DEPARTMENT OF TRANSPORTATION**National Highway Traffic Safety Administration****49 CFR Part 571**

Federal Motor Vehicle Safety Standards; Door Locks and Door Retention Components

ACTION: Final rule; response to petitions for reconsideration; technical amendments.

FIGURE 7 - VEHICLE COORDINATE REFERENCE SYSTEM FOR INERTIAL TESTING

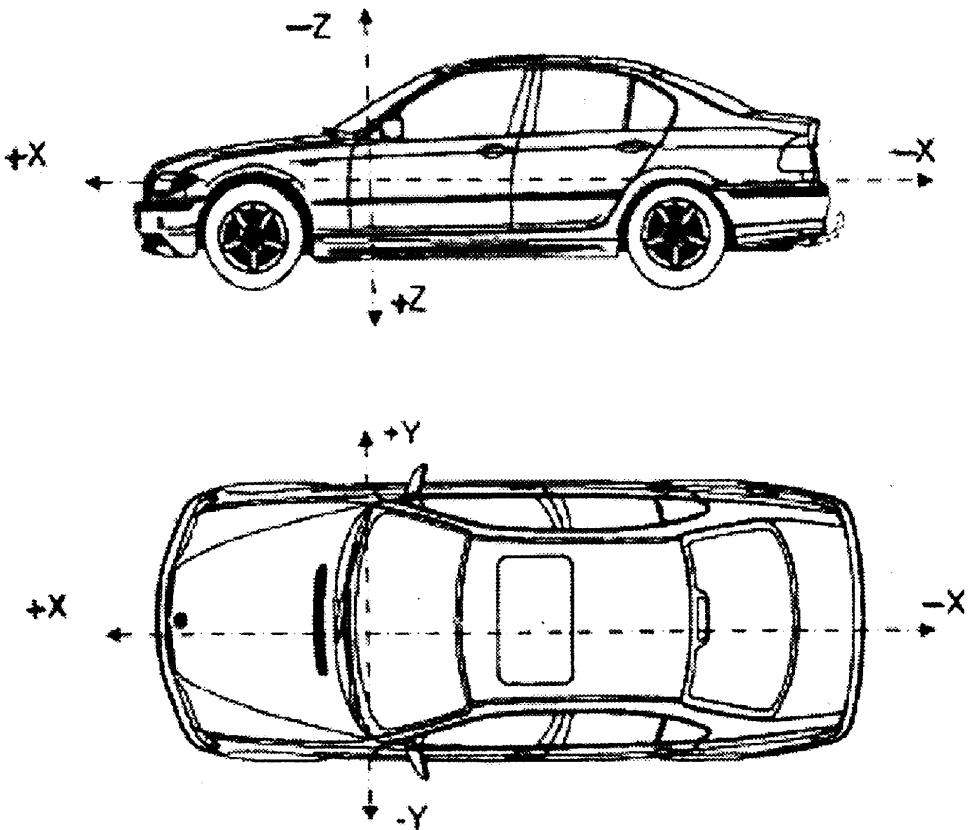
b. Technical Amendment to Figure 7

Prior to the February 2007 final rule, FMVSS No. 206 did not have a figure that graphically displayed the vehicle coordinate reference system to be used for inertial testing. The GTR provided such a figure because part of the GTR referenced various directions with respect to different vehicle axes. The NPRM proposed, and the February 2007 final rule adopted, this same GTR figure as Figure 7.

Although the agency did not receive any comment regarding Figure 7 in response to both the NPRM and the February 2007 final rule, after publication of the final rule NHTSA realized that x-axis and the z-axis in Figure 7 were not consistent with SAE J211 (Instrumentation for Impact Test) or with the sign conventions used in other Federal motor vehicle safety standards such as FMVSS No. 208 and FMVSS No. 214. Therefore, NHTSA is making a technical amendment to FMVSS No. 206 by modifying Figure 7 to be consistent with SAE J211 and the sign convention for other Federal motor vehicle safety standards as follows:

X = longitudinal direction
Y = transverse direction
Z = vertical direction
